PLANNING DIVISION STAFF REPORT

July 7, 2025

Project Address: 709 Northport Drive (18th Alder District)
Application Type: Conditional Use and Certified Survey Map Referral
Legistar File ID # [88336](#) and [88558](#)
Prepared By: Chris Wells, Planning Division
Report includes comments from other City agencies, as noted.
Reviewed By: Kevin Firchow, AICP, Principal Planner

Image A: The Site Plan Overlaid on the Aerial Showing the Proximity of the Residential to the West and Proposed Massing Stepbacks at the Fourth Floor Level

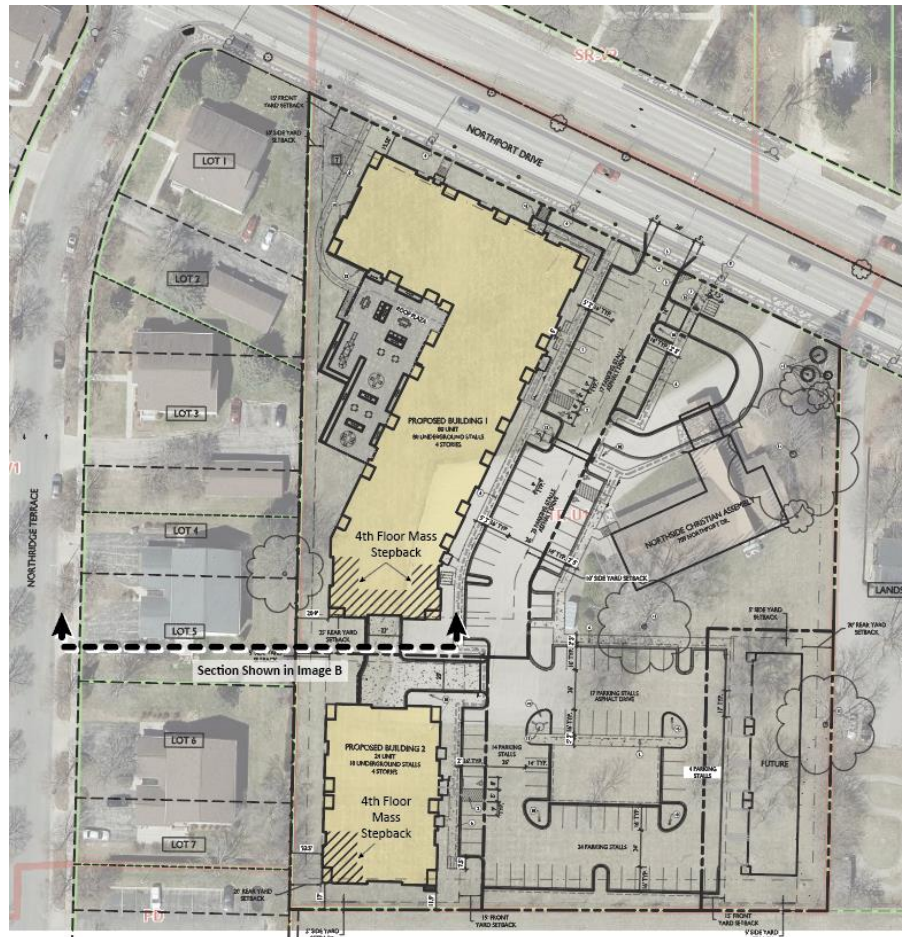
Second, the applicant has introduced stepbacks in certain locations at the fourth-floor level along portions of the west façades – by locating the fourth floor rooftop patios at the south end of the 80-unit building and southwest corner of the 24-unit building. (These rooftop patios are indicated with a diagonal hatched line in Image A (see right).

In response to Planning's staff's follow-up questions regarding stepbacks, the applicant indicated they would be willing to move the stepback at the southern end of the building to the western wing, but raised programmatic concerns of creating setbacks at both locations. Staff note that the residential building located near the current stepback is closer than the one at the north, and therefore, believe that it may be more impactful as proposed.

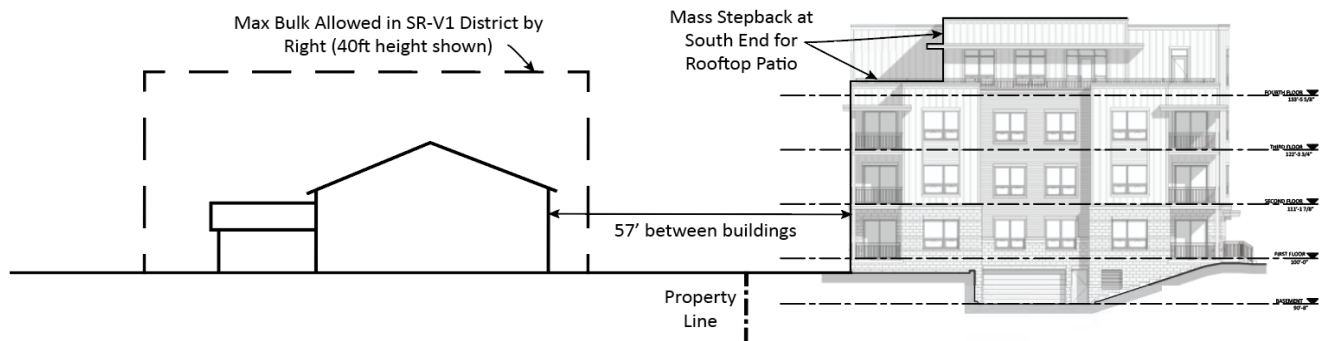
Image B (below) shows the relationship between the proposed buildings and the adjacent residential lots to the west – which contain gable-roofed, two-story, four-unit buildings and are zoned SR-V1 (Suburban Residential – Varied 1). While these lots are currently developed at a lower intensity than what is allowed by the Zoning Code, Staff note that SR-V1 allows such buildings as 3- to 4-unit, single-family attached dwellings and 3- to 8-unit multi-family buildings, up to three stories and 40-feet in height, as permitted uses.

Image B depicts a dashed line estimating the maximum building bulk currently allowed by right in the SR-V1 District. While the transition from the proposed flat-roofed, four-story buildings to these tall, two-story buildings is roughly two stories, the proposed building is approximately only one-story taller than what is currently allowed, by right, on these abutting sites.

Regarding building height, before final sign off by Zoning, the applicant will need to make sure the height of the 24-unit building is not greater than 52 feet (Zoning is currently measuring it at 53 feet).

In regards to the lower level that creates the elevated patio along the western side of the property, staff recommend that the applicant revise the planting plan to introduce taller plantings that can better screen the relatively long blank walls. A condition of approval has been recommended.

1. The applicant shall revise the landscaping plan to provide additional plantings that provide additional height and year-round screening for the base of the elevated patio wall along the western side of the building. Such plantings shall be planted at a large size to provide screening benefits at the time of planting.
